Modification of Approval

Restoration and refurbishment of the Sirius Site (SSD_10384_Mod 3)

2-60 Cumberland Street, the Rocks

August 29, 2022

Figure 2: North Elevation Approved (RHS) and Proposed (LHS)

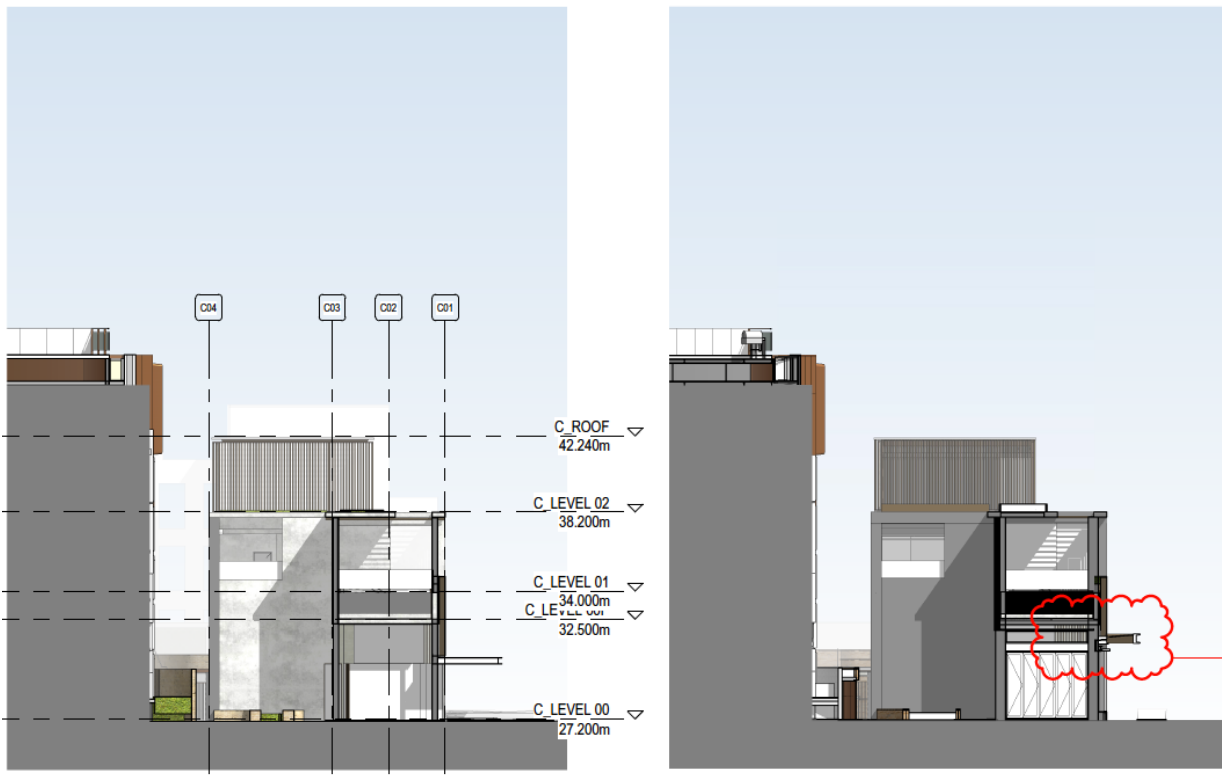
- Reduce the width from 3m which extended to the face of the kerb to 1.78m to avoid any conflicts with vehicles on Cumberland Street and for greater consistency with the Sydney DCP which requires awnings to be setback 1m from the face of the kerb
- Increase the height from 2.50m to 3.20m to ensure consistency with the Sydney DCP which requires awnings to be between 3.2m and 4.2m above the footpath.

This is shown at Figure 2 and in the plans at Appendix B. The relevant provision of the Sydney DCP are further discussed in Section 4.4.

The amended awning would have a height of 3.20m consistent with the DCP requirement. The proposed width of 1.78m is less than required range of 2m to 3.6m but meets the requirement to be at least 1m from the face of the kerb.
